Addendum 93 – UN Regulation No. 94

Revision 3 - Amendment 2

Supplement 2 to the 03 series of amendments – Date of entry into force: 3 January 2021

Uniform provisions concerning the approval of vehicles with regard to the protection of the occupants in the event of a frontal collision

Figure 4

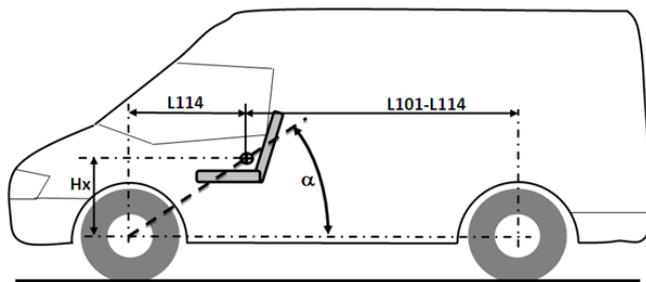
Insert new paragraphs 5.3. to 5.3.2., to read:

"5.3. Specific provisions

5.3.1. Vehicles of category M₁ of a total permissible mass exceeding 2,500 kg that are based on vehicle types of category N₁ of a total permissible mass exceeding 2,500 kg are deemed to meet the requirements of paragraph 5. where the requirements of UN Regulation No. 137 are fully complied with and at least one of the following conditions is met:

- (a) The acute angle alpha (α), measured between a horizontal plane passing through the centre of the front axle and an angular transverse plane passing through the centre of the front axle and the R-point of the driver's seat (see Figure 4 below), is more than 22°;
- (b) Or the ratio between the distance from the driver's R-point to the centre of the rear axle (L101-L114) and the centre of the front axle and the driver's R-point (L114) is more than 1.30 (see Figure 4 below).

5.3.2. Vehicles of category N₁ of a total permissible mass exceeding 2,250 kg but not exceeding 2,500 kg are deemed to meet the requirements of paragraph 5, where their structural basis is a ladder frame and the requirements of UN Regulation No. 137 are fully complied with and at least one of the following conditions is met:

- (a) The acute angle alpha (α), measured between a horizontal plane passing through the centre of the front axle and an angular transverse plane

passing through the centre of the front axle and the R-point of the driver's seat (see Figure 4 below), is more than 22°;

- (b) Or the ratio between the distance from the driver's R-point to the centre of the rear axle (L101-L114) and the centre of the front axle and the driver's R-point (L114) is more than 1.30 (see Figure 4 below).
